Reply to Office Action dated December 1, 2006

Serial No. **10/800,036**

Docket No. **YHK-0089.1**

FIG.5

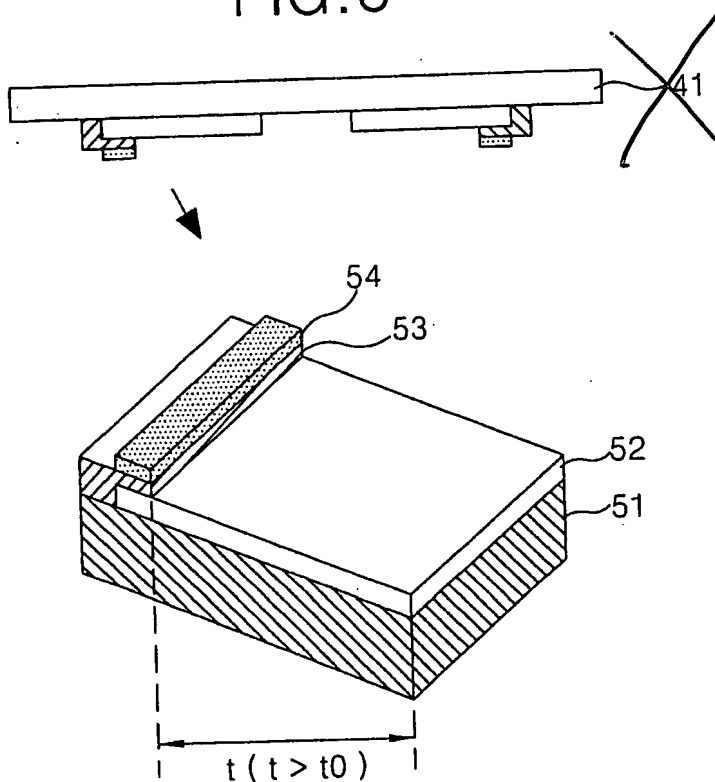
The Office Action objects to the drawings because the FIG. 5 reference character "41" is not mentioned in the specification. The above replacement figure does not include the reference character "41". Withdrawal of the objection is respectfully requested.

The attached drawing includes changes to Fig. 5. This sheet, which includes Fig. 5, replaces the original sheet including Fig. 5. In Fig. 5, element "41" is deleted.
